SERVICE LETTER 185

10000 Nutplate Installation

Aircraft Makes/Model(s):	Float Model(s):	Compliance: Optional	By: MAB
AT-802 AT-802A	10000A	Part Number: 1009886	Approved: SDW
		Date: 6/6/2019	Revision: B

Scoop Tunnel

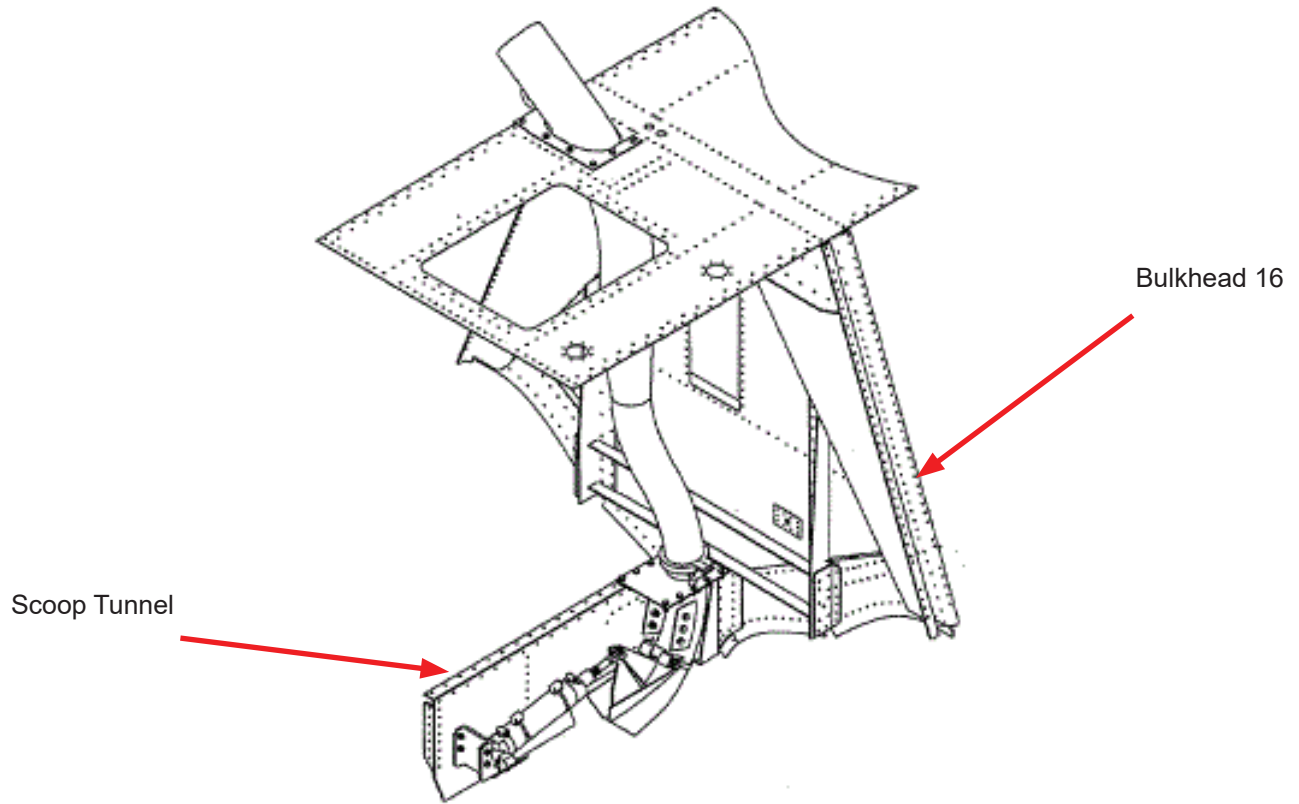
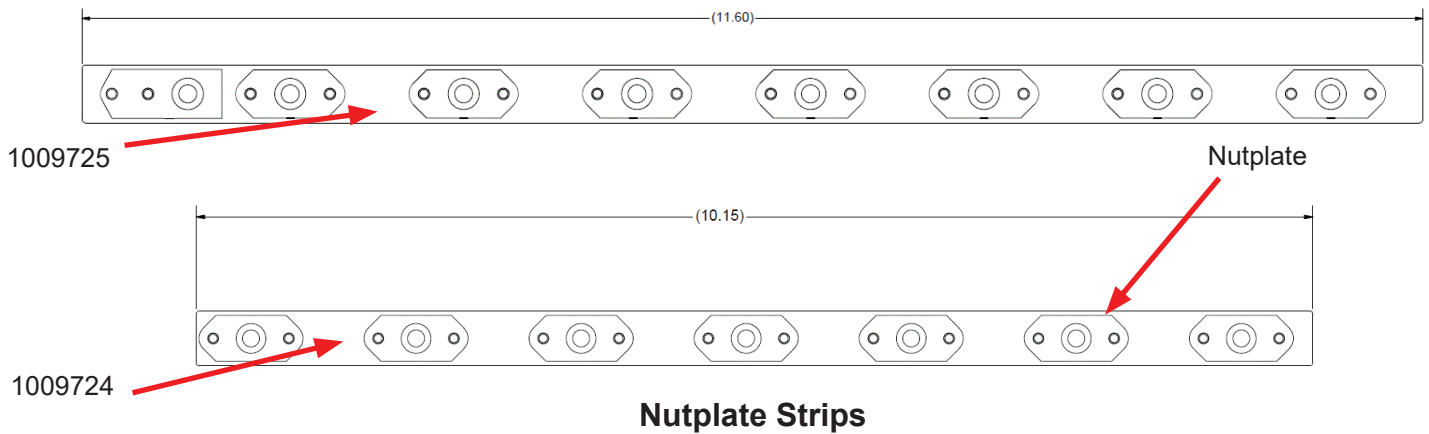
1. Access scoop tunnel through aft panel in foam/baggage compartment.
2. Remove hardware and covers on top of scoop tunnel.
3. Discard hardware (nuts and washers) on bottom of scoop tunnel flange.
4. Clean sealant from covers and top and bottom of flanges.
5. Reinstall covers with PR-1422 or equivalent using nutplate strips on bottom and existing bolts and washers.
Note: 1009724 (10.15") goes forward and 1009725 (11.60") goes aft.
6. Leak check scoop tunnels.

Nutplate Strip

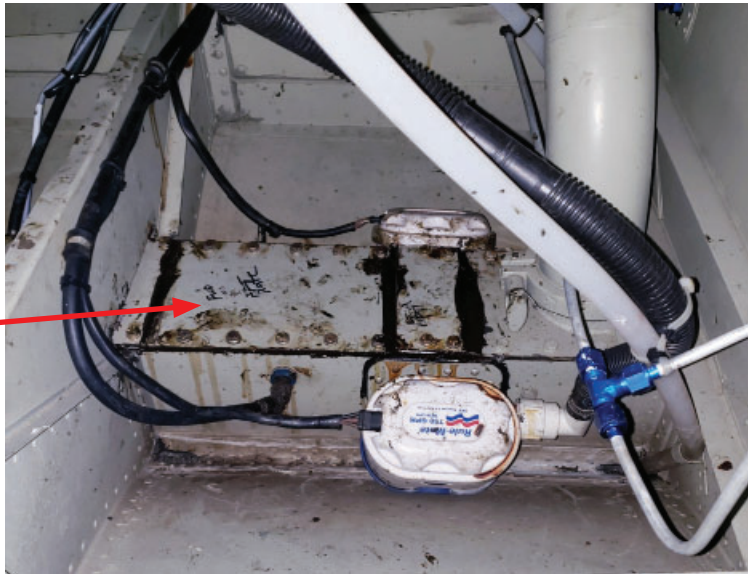
Traditionally, the scoop tunnel on the Air Tractor uses nuts, washers, and bolts. Due to tight quarters, it is difficult to access when performing maintenance. This service letter provides a nutplate strip installation for easier maintenance in the future.
